FOR
LANCASTER SEED SALES
2914 HOMESTEAD ROAD

SUBJECT: Lancaster Seed Sales
Preliminary/Final Land Development Plan Submission Modification Requests
DCG Project Number **5132-50**

Re: Lancaster Seed Sales
Preliminary/Final Land Development Plan
Township Permit No.25-07-FLDP
LCEC Project No: 25-190

We have received a preliminary/final land development plan submission from D.C. Gohn Associates, Inc. for the above-referenced project. The submission consisted of the following documents:

DRAWING #: CG-4053
SHEET #: 6 OF 12

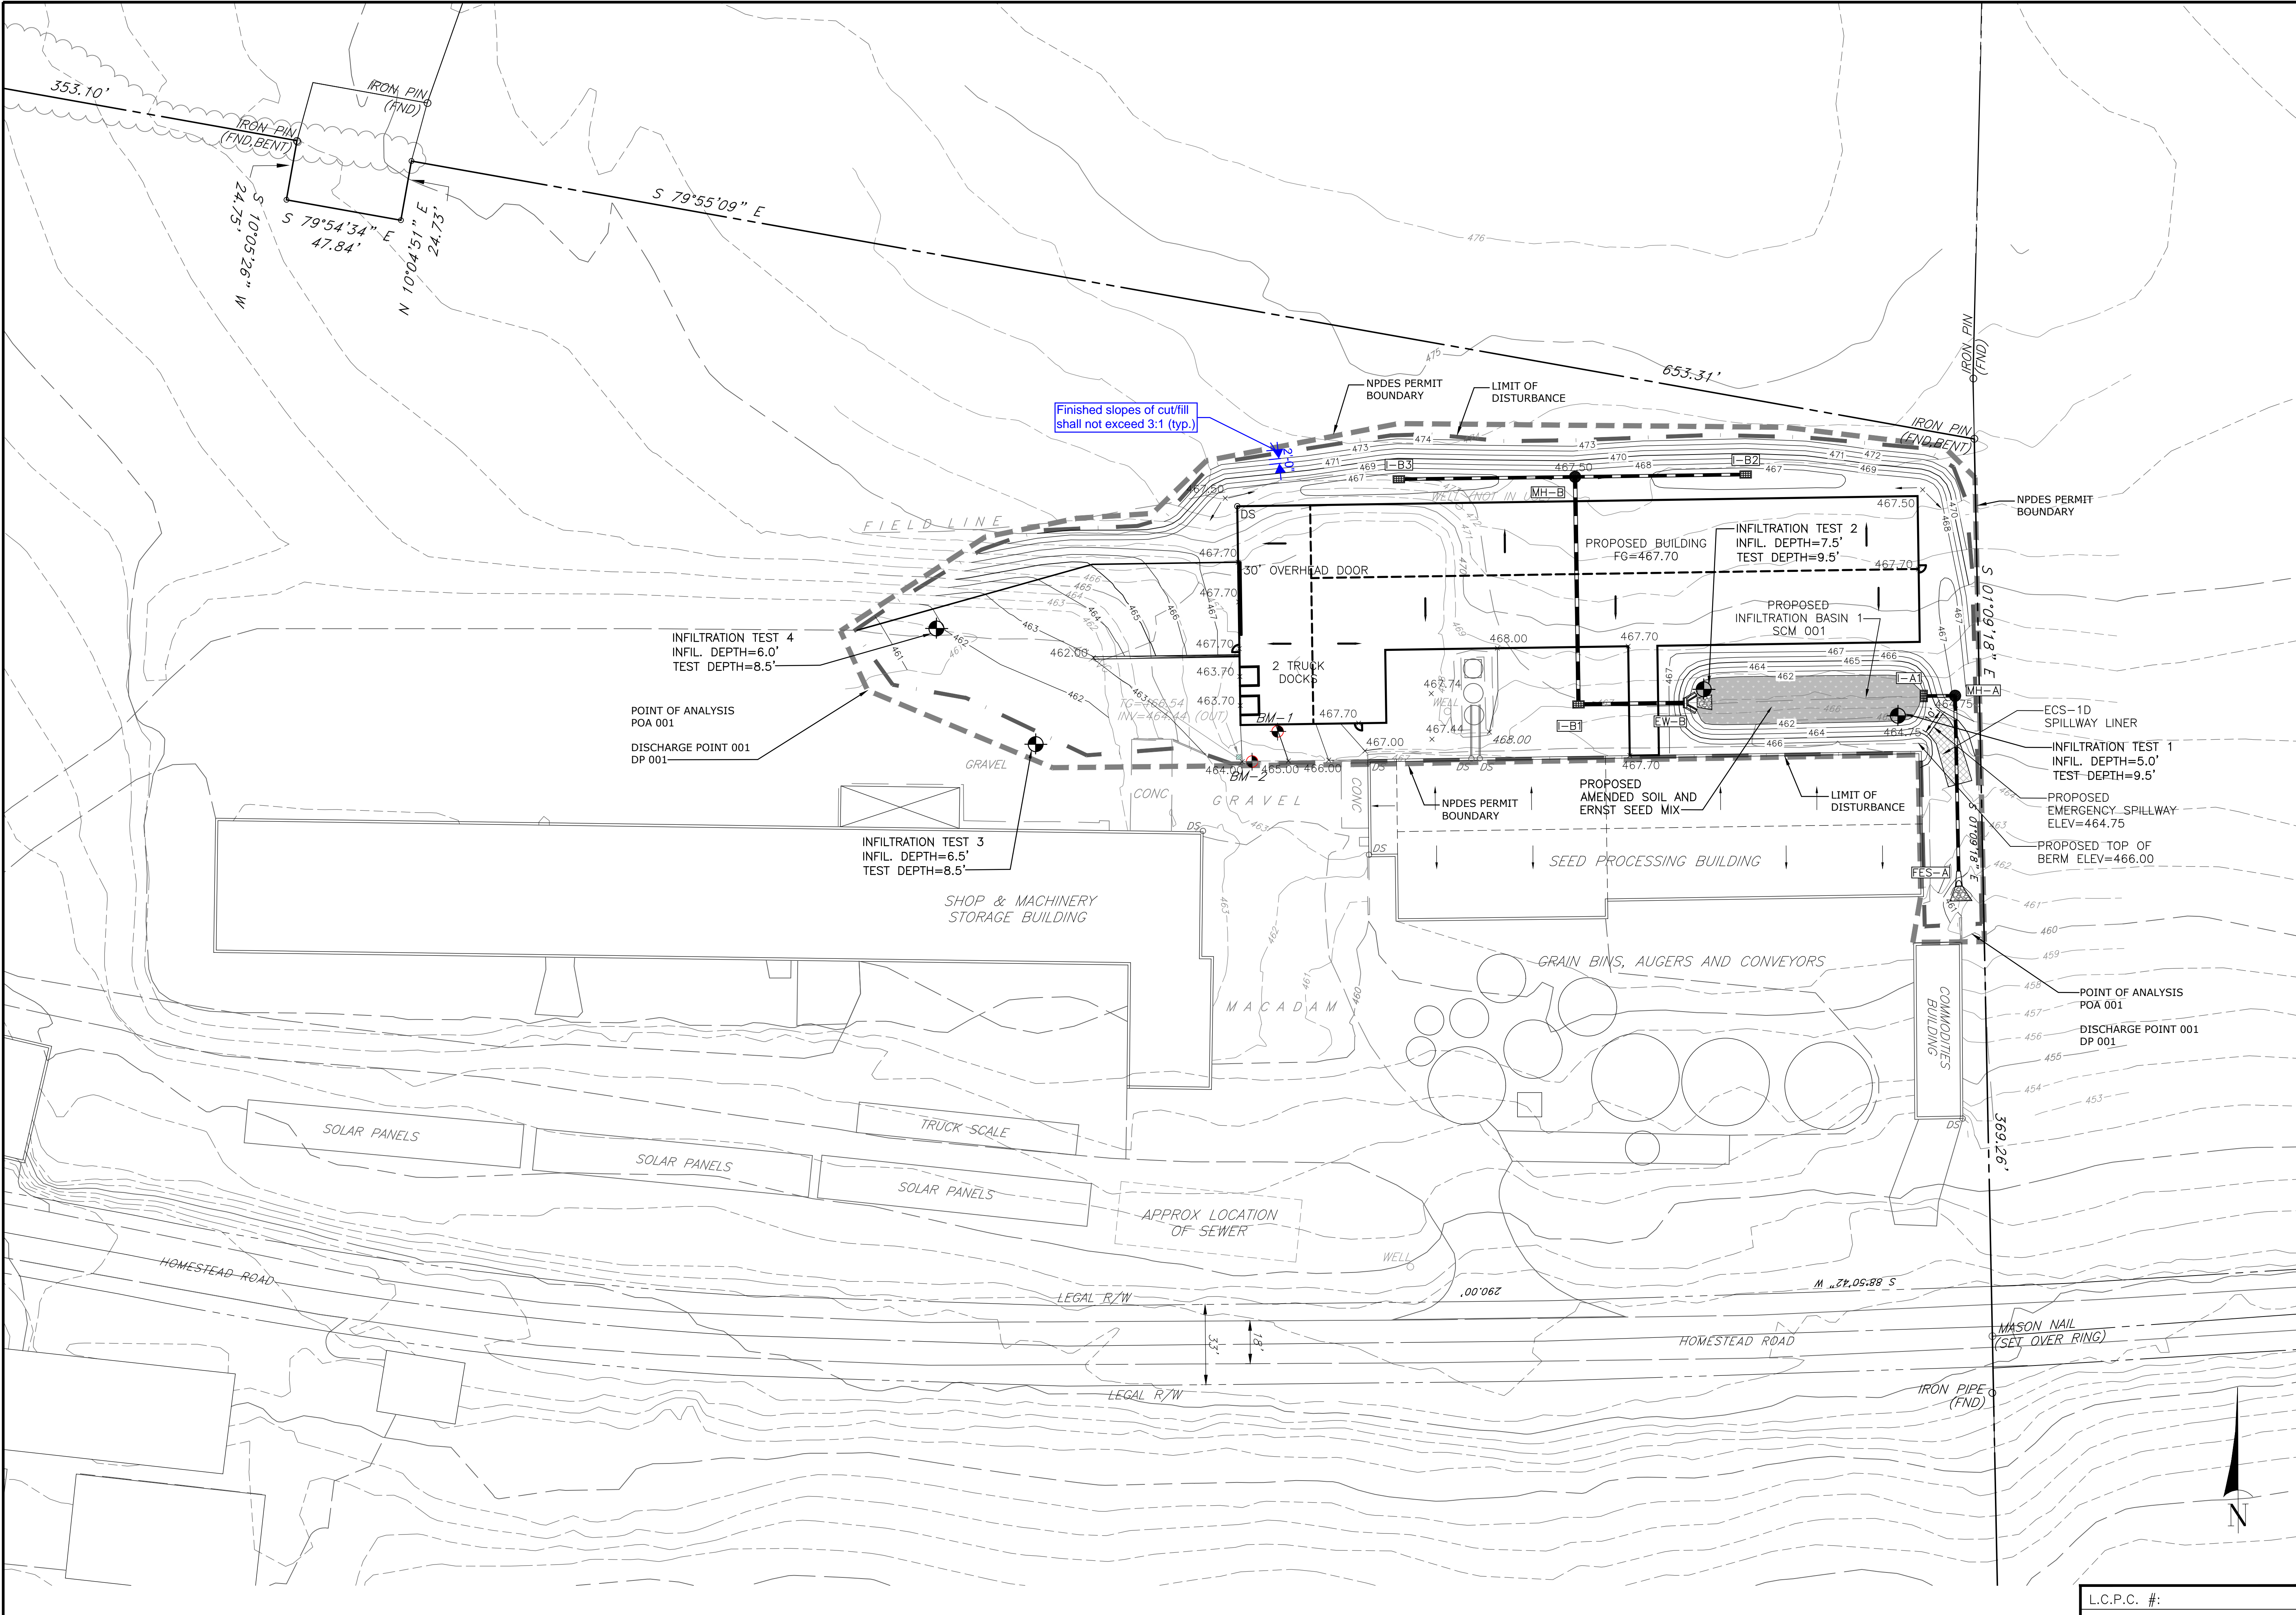
48. The plans shall indicate where the downspouts are located to confirm the Post To Infiltration Basin 1 drainage area and I-B1 subdrainage area boundaries are correct (113-35.B).

53. The plans shall show the proposed top width, interior and exterior side slopes for the infiltration basin embankment (113-37.A(1)).
54. The applicant has requested a waiver of the requirement to provide a maximum interior side slope of 3:1 for aboveground storage facilities; however, since proposed Infiltration Basin 1 is less than 2 feet deep this waiver is not needed. The modification request letter shall be updated to remove the reference to this request (113-37.A(1)(a)[2]).
